Vertical sidebar containing project information: CITY OF ROCHESTER, PORTLAND AVENUE REVITALIZATION, GENERAL NOTES, LEGEND, AND INDEX, copyright notice, and drawing title GN-1.

PORTLAND AVENUE REVITALIZATION PROJECT
 CITY OF ROCHESTER
 MONROE COUNTY, STATE OF NEW YORK

CITY OF ROCHESTER, NEW YORK
PORTLAND AVENUE REVITALIZATION
CONSTRUCTION DETAILS

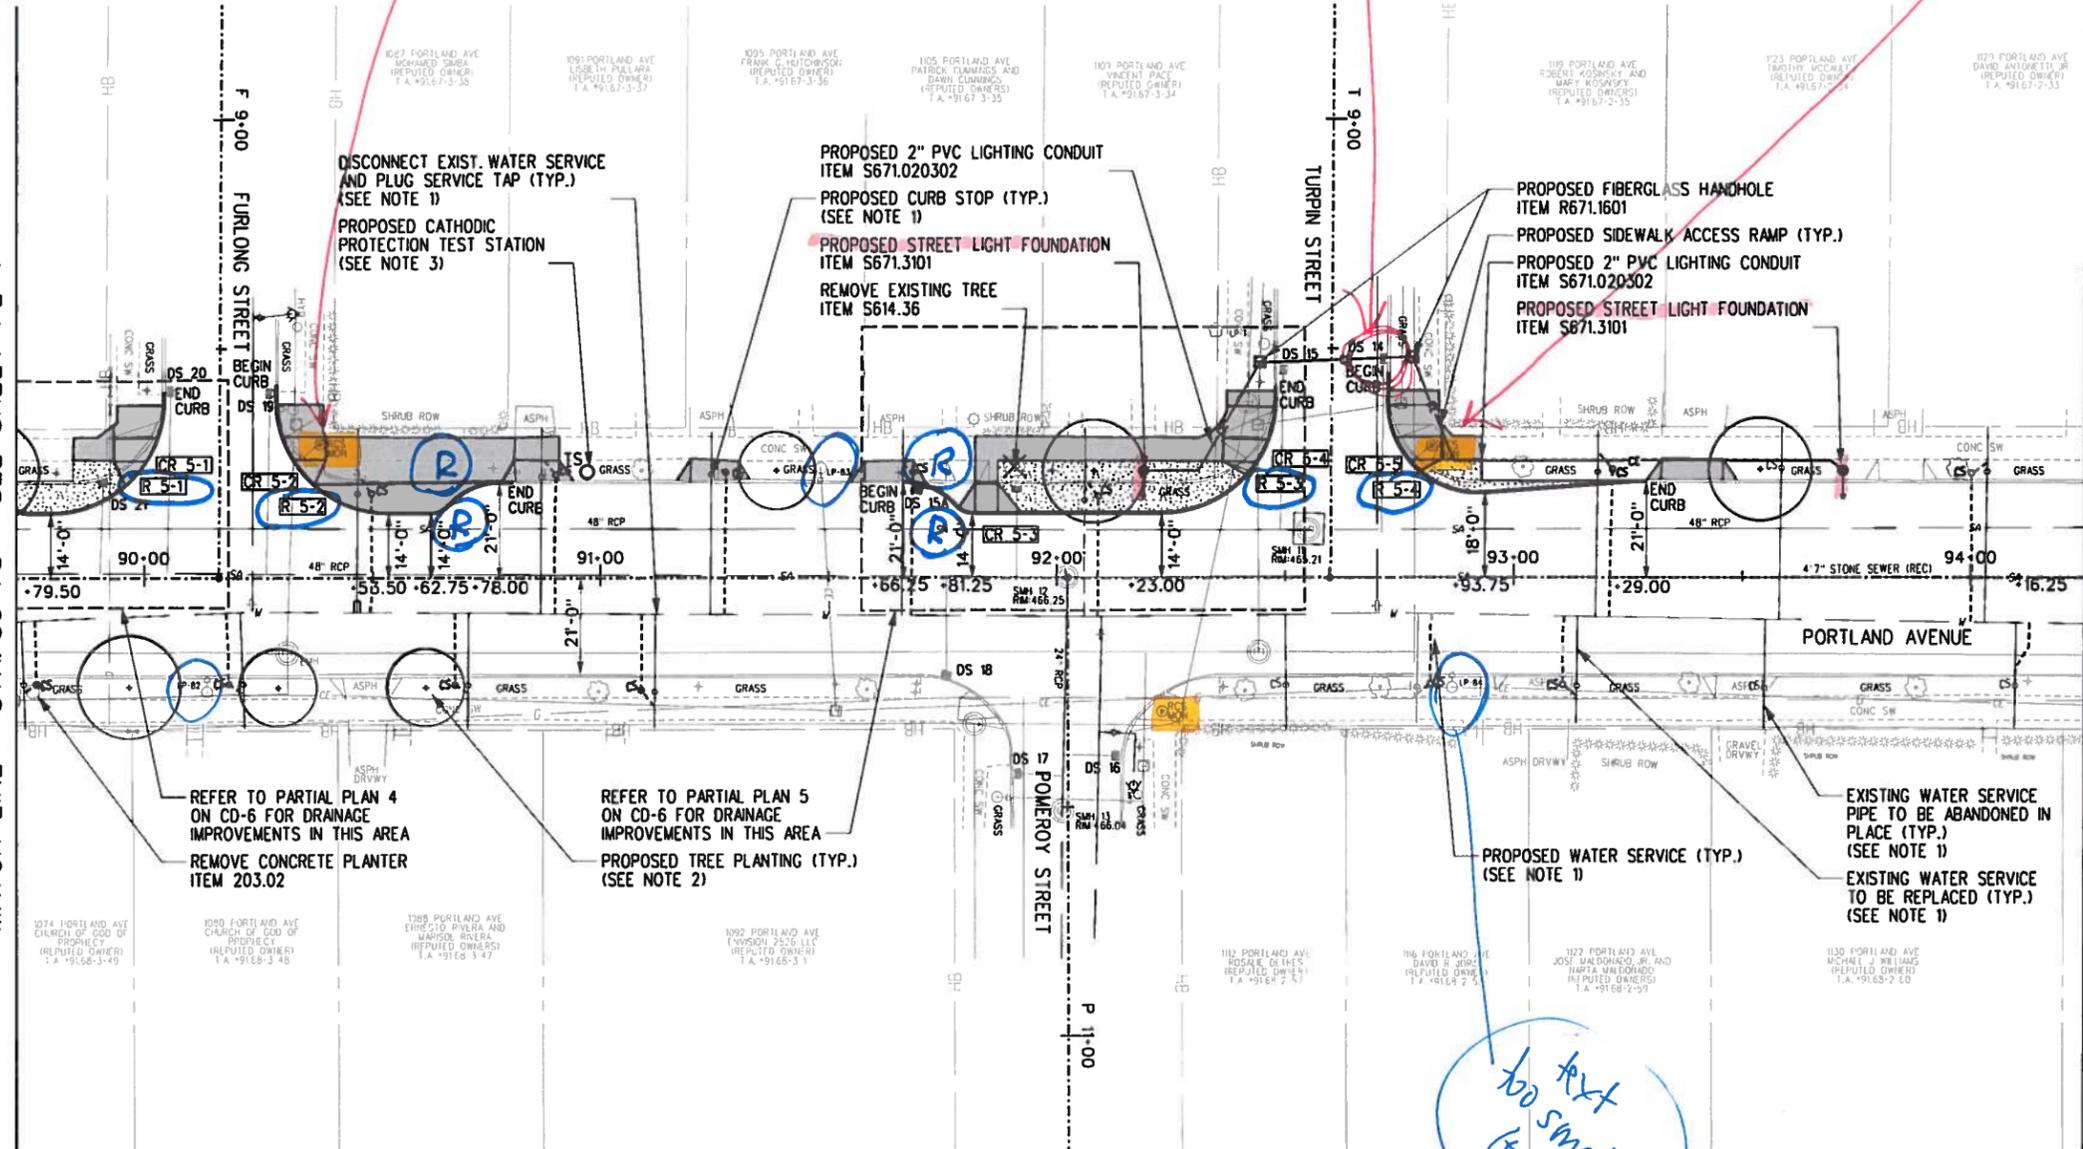
Replace Frame
Install New Mon-Frame & Cover S626.06

PREVIOUS COMMENT!!
CE CONDUIT CONTACT WITH CE

DRAWING NO: PL-6
SHEET 37 OF 41
WENDEL JOB NUMBER: 22134062

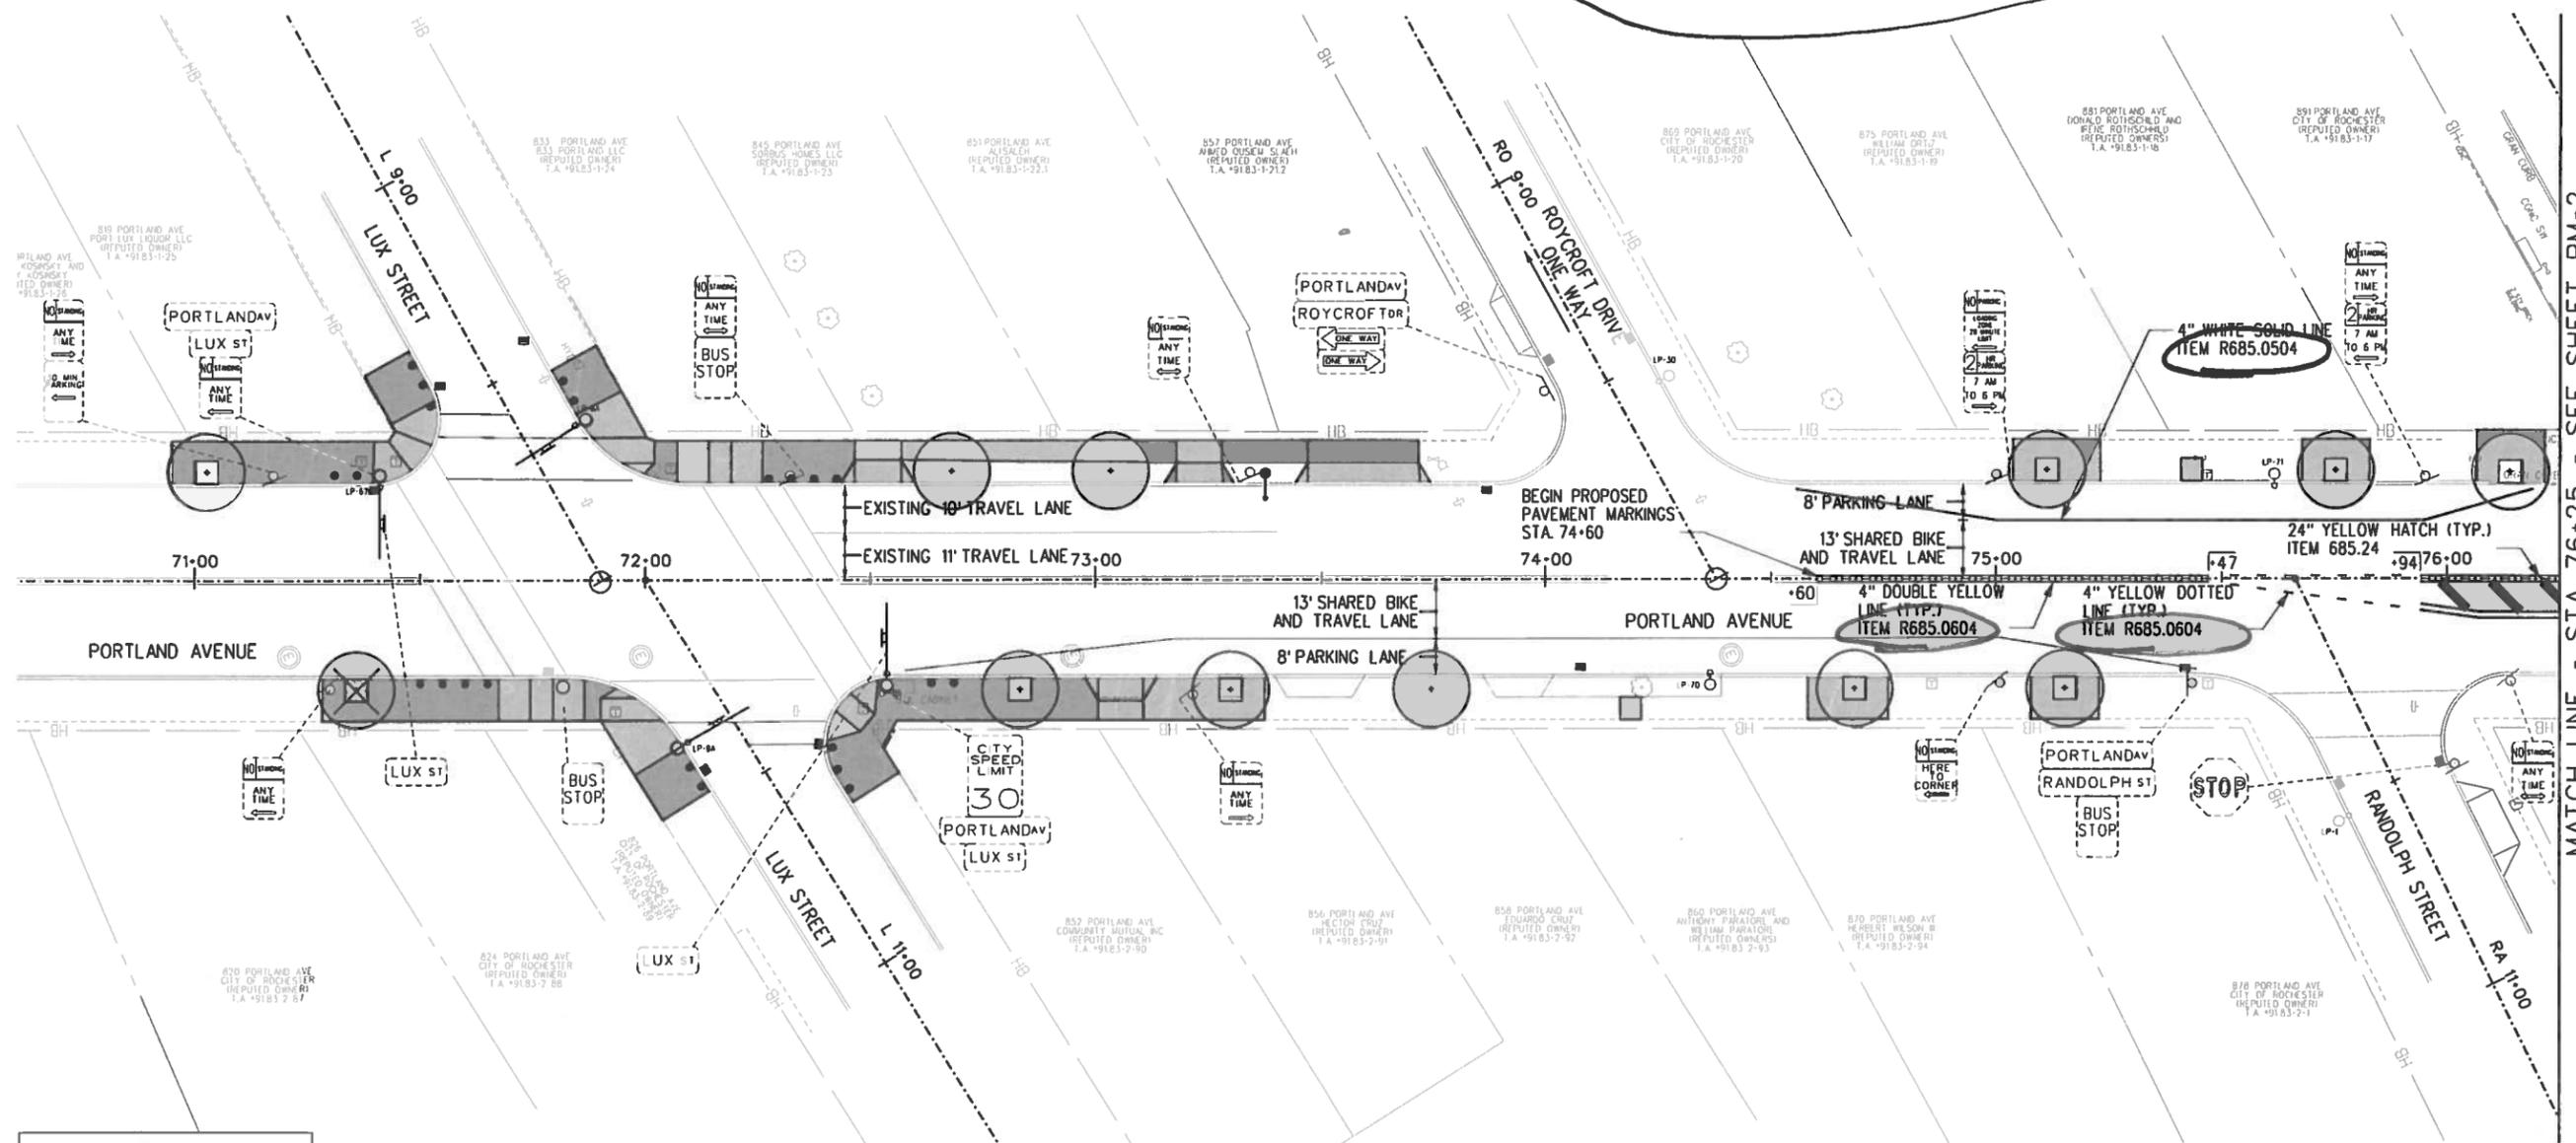
SEE PREVIOUS COMMENT!!
DO EXIST. BOLLARDS NEED TO BE REPLACED??
(I THOUGHT IT WAS DECIDED NO ...)

CITY OF ROCHESTER, NEW YORK
 PORTLAND AVENUE REVITALIZATION
 PAVEMENT MARKING AND SIGNAGE PLAN

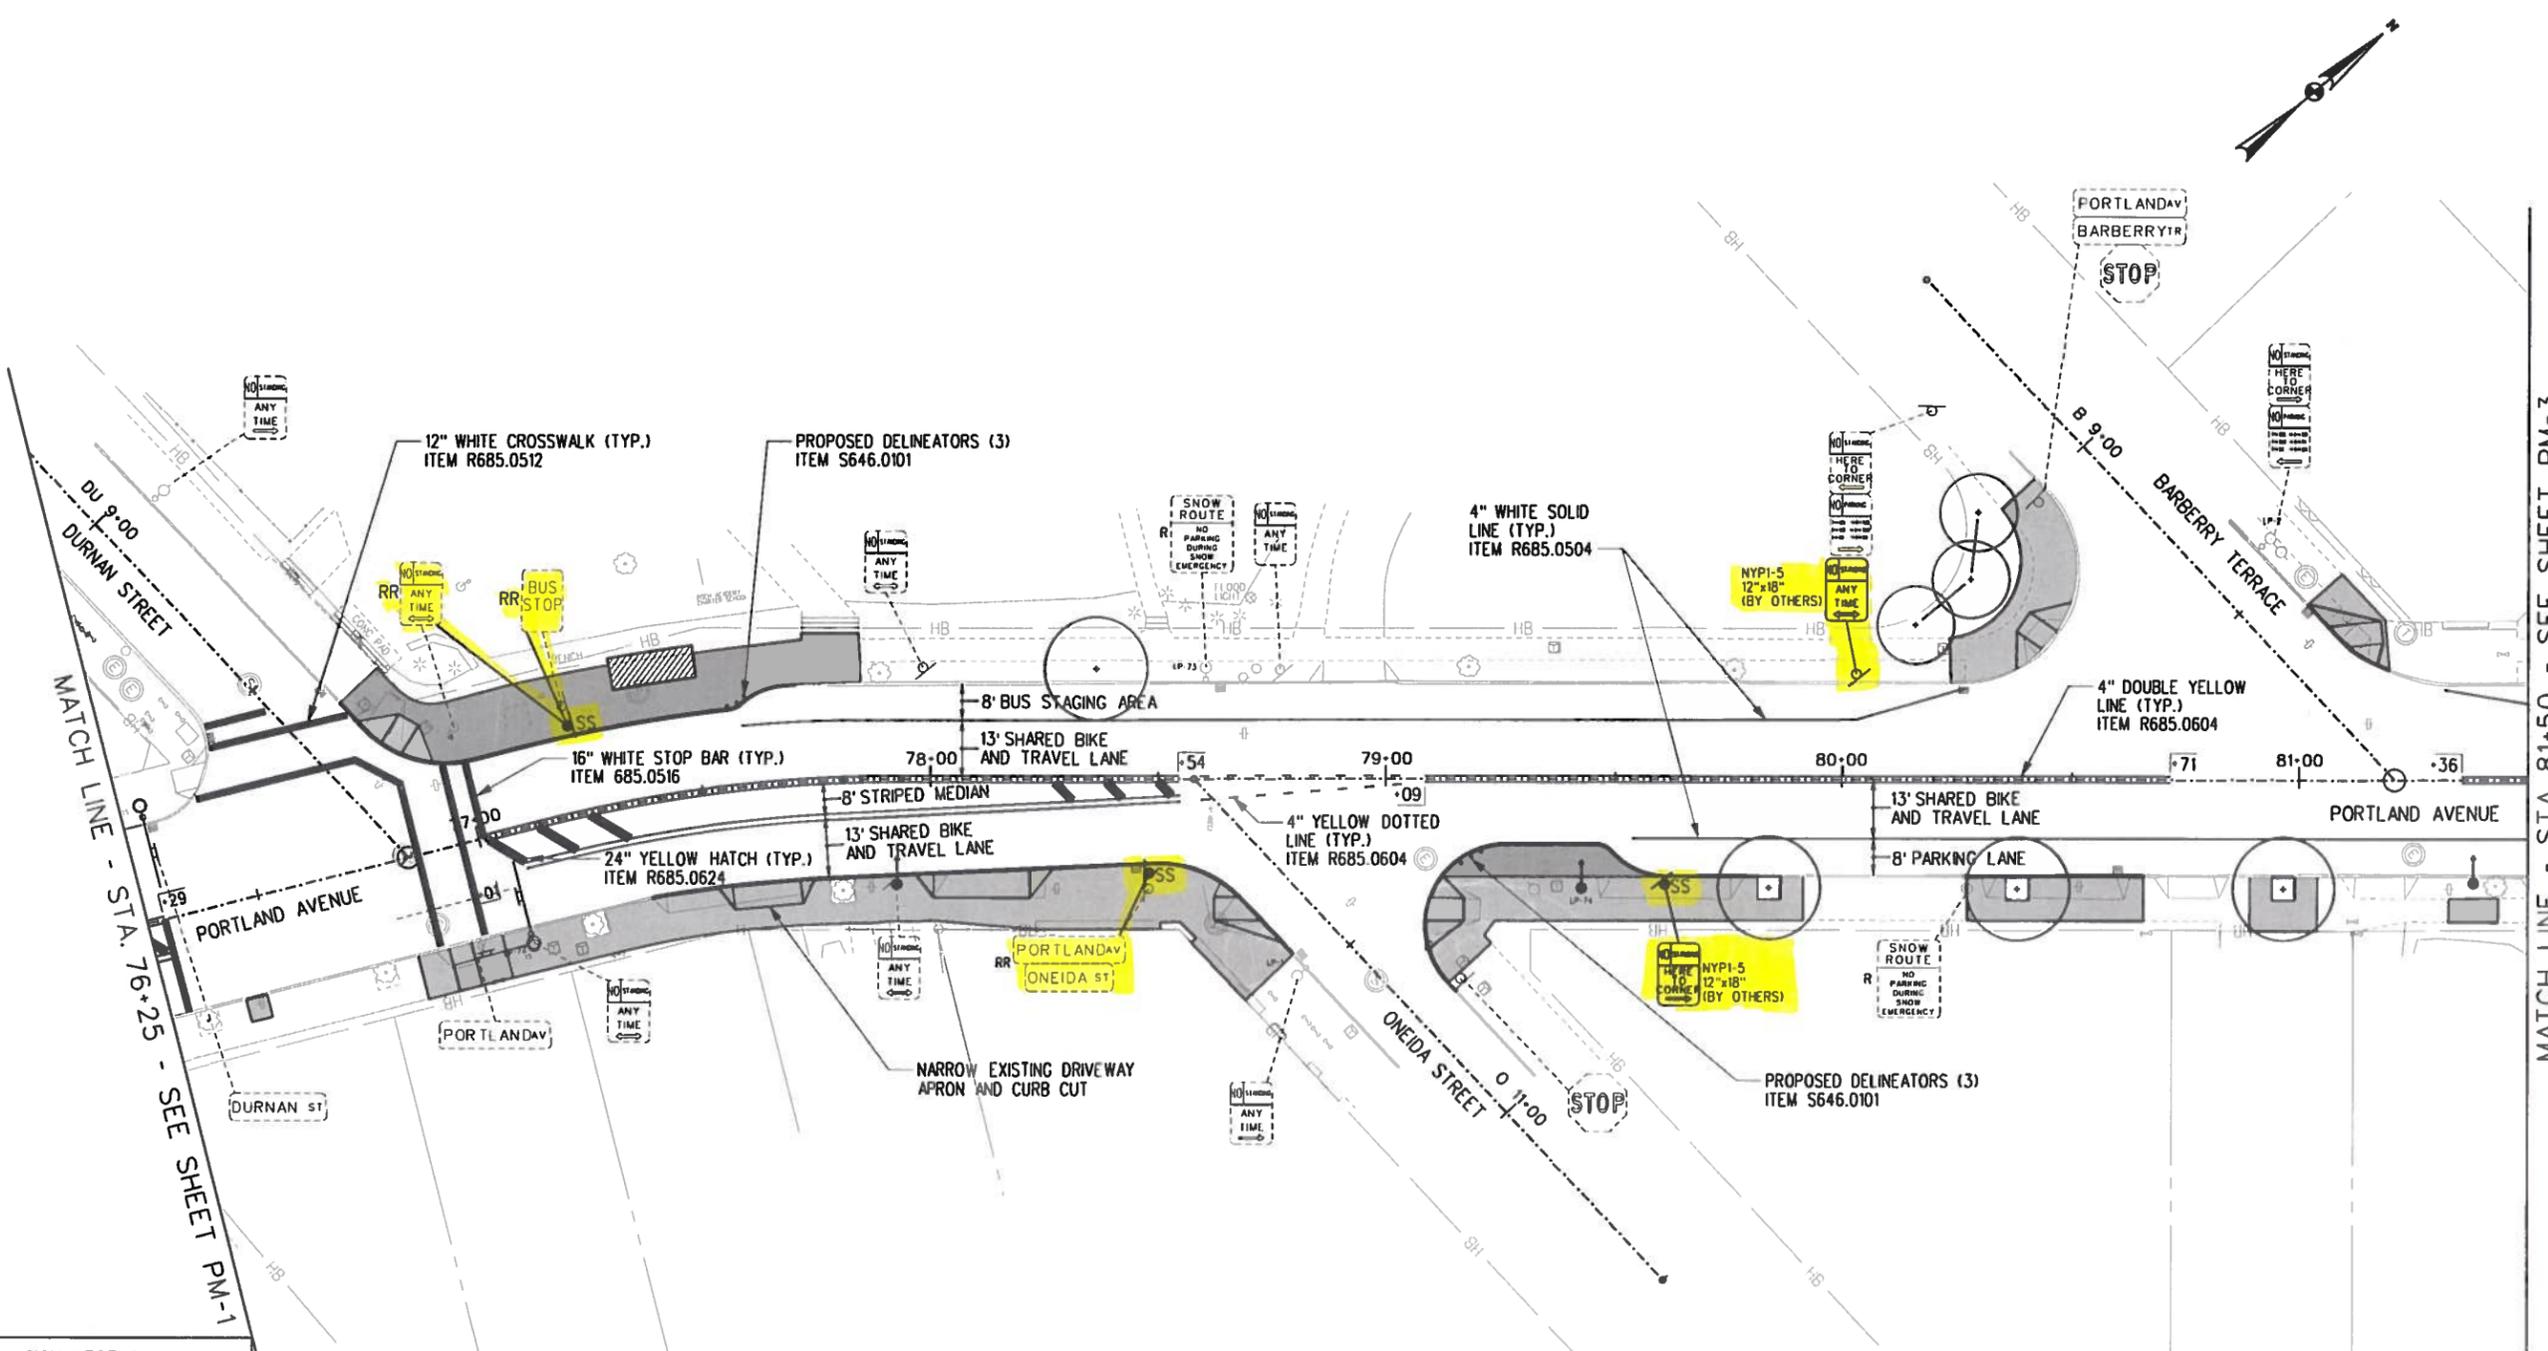
USE PAINT NOT PLASTIC STRIPING Temporary until PM project
